RE: Revised 698 Massachusetts Avenue Special Permit Application PB#373, Citizen's Bank at 698 Massachusetts Avenue Financial Institution Use within Central Square Overlay Continued March 2, 2021.

Supplemental Narrative Comments & Discussions w/ Erik Thorkildsen (CDD) 3/25, 4/6, 5/5

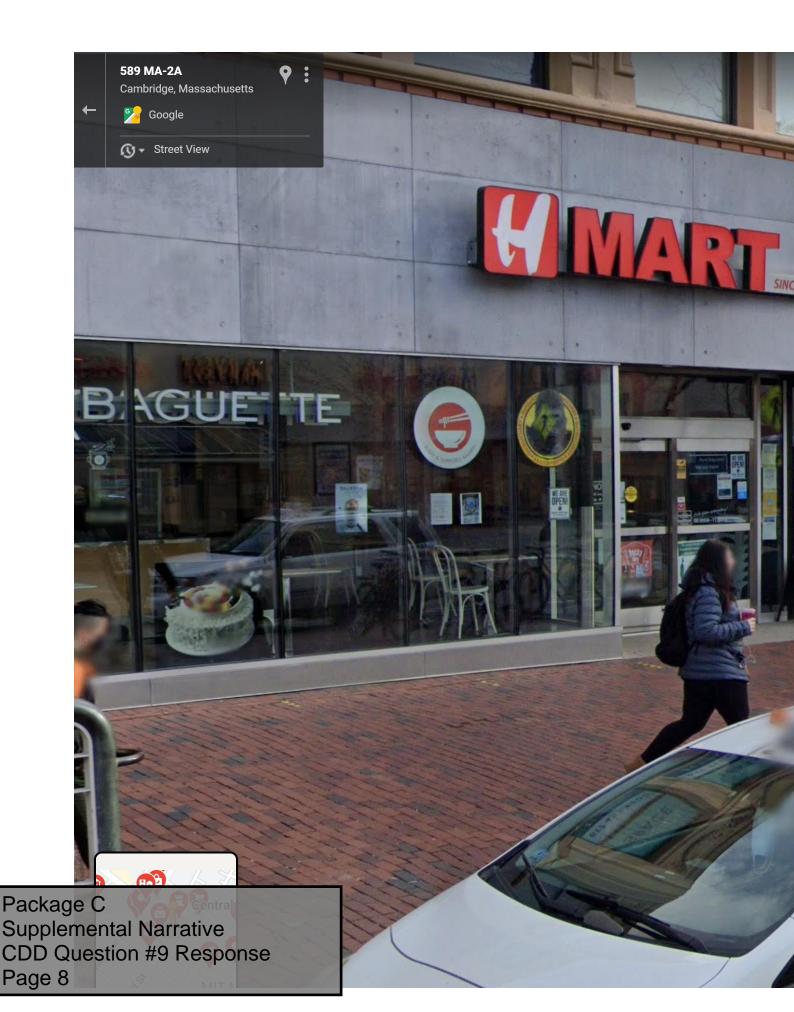
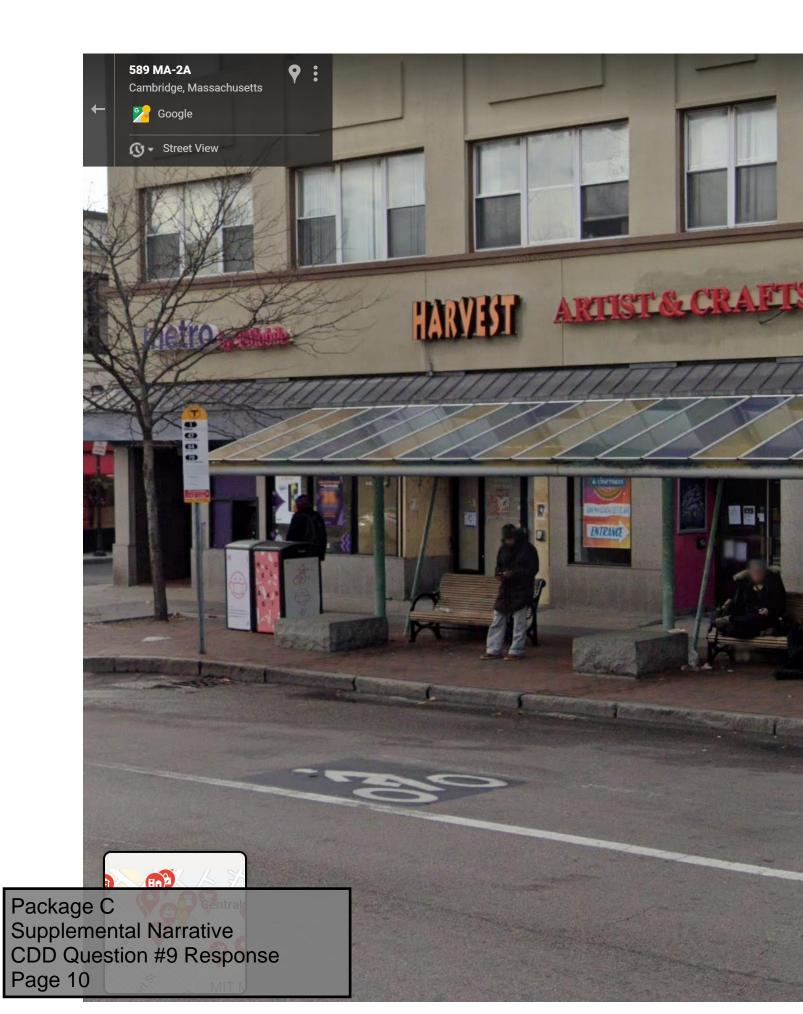
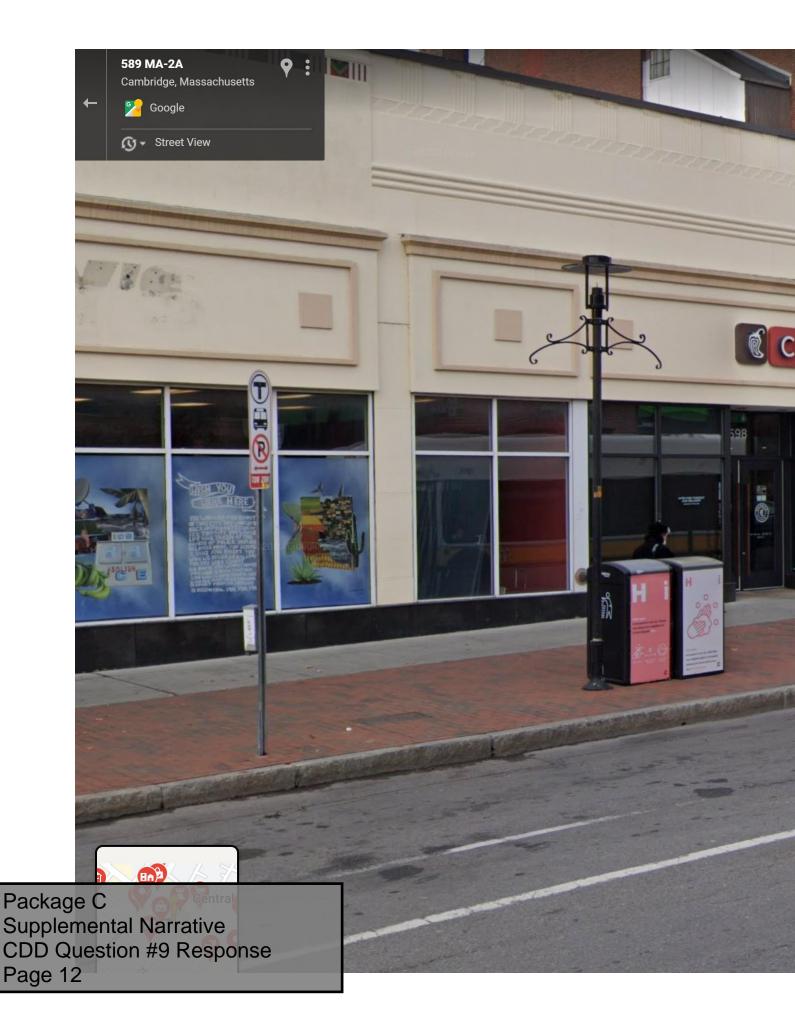
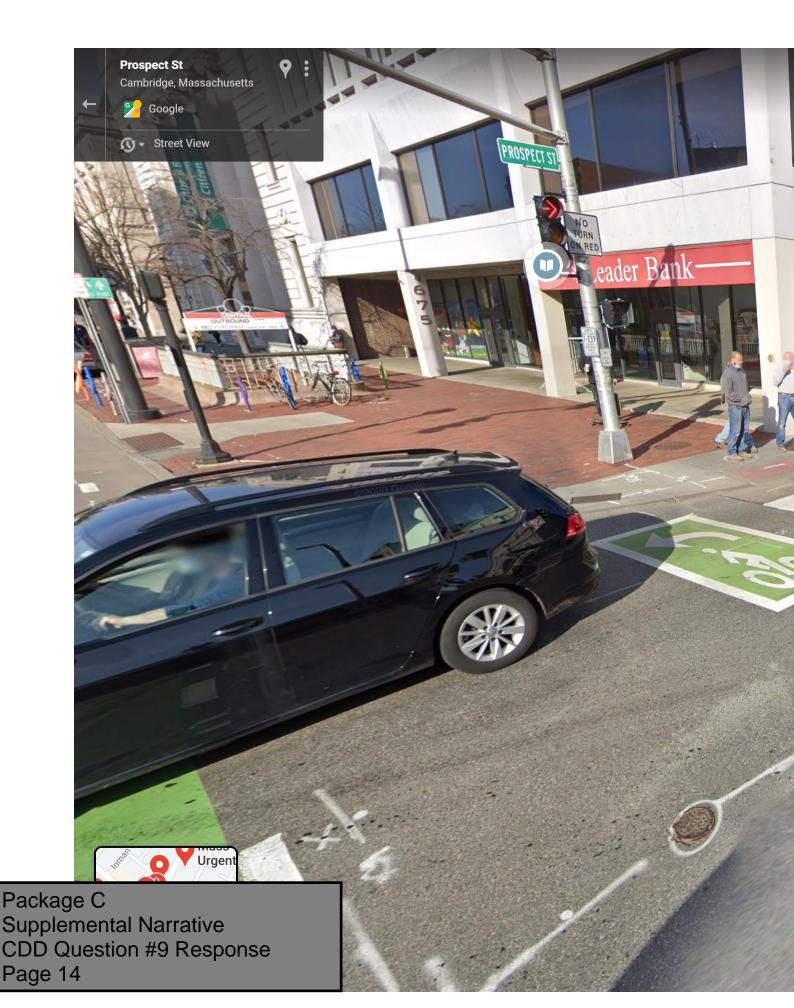
A description of how the proposed storefront/awning/signband is compatible with the zoning would be helpful, including how the proposal differs from the standard design and how they relate to Central Square. (See the Ordinance for the exact text.)

Answer: The awning has been completely removed from the project. The proposed signage is a "wall sign" as defined in article 7.13.2 as the sign is parallel to the plane of the building to which it is attached and less than 12" from the face of the building.

Further the sign is compliant with article 7.16.22 as the square footage measurement for the 18"h letters we are proposing is 15 SF. Overall size measurements are 19-5/8" (h) x 112-1/2" (w) with 18" "C" cap height. The overall square footage of the sign is lower than would be allowed and less that than what would be allowed if the frontage were compliant. Article 7.16.22 which states:

The signage is also compliant with <u>Article 20.304.5 (4) Formula Business District</u> as it deviates greatly from the typical "green awning" design that most Citizen Bank locations have and maintains a subdued presence from the streetscape that is similar in look and feel to many existing Central Square business signs. The color scheme has been inverted deviating from other locations in the area. The color "Silver Bells" has been introduced for the first time for any Citizen's Branch which will make the locus unique in color scheme reflecting the eclectic and unique look and feel of Central Square. This unique look for Citizen's Bank will also be accented by vinyl graphics on the interior of the left facing glass façade with a digital screen which Citizen's may use to promote events in Central Square and other elements of the Cultural District.

Package F Additional Requested Materials Signage Exhibit Page 5

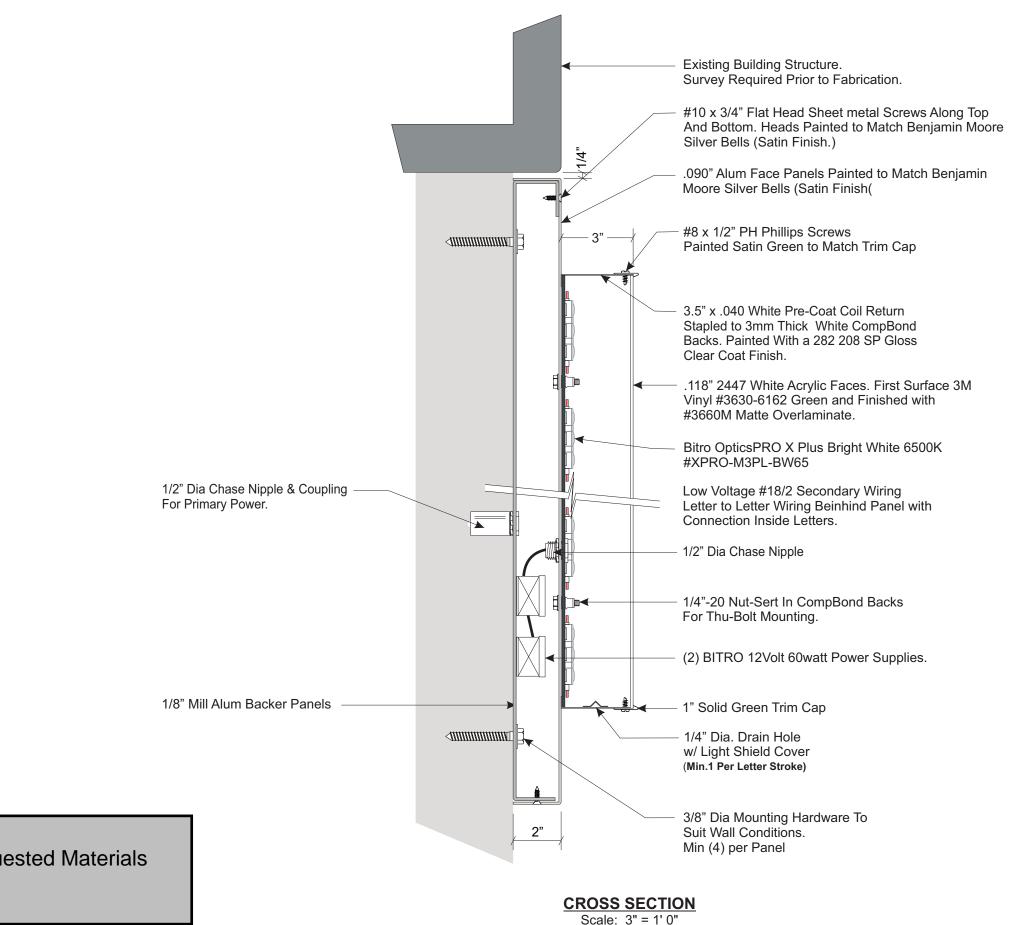
What is its proposed profile in section? Is the proposal an awning or a vertical surface, and if an awning, how far does it project?

Awnings were removed from scope of project and projection of vertical bands and lettersets were held as tight to the vertical plane as possible.

Refer to Package F, Page 5 for additional details regarding letterset projections.
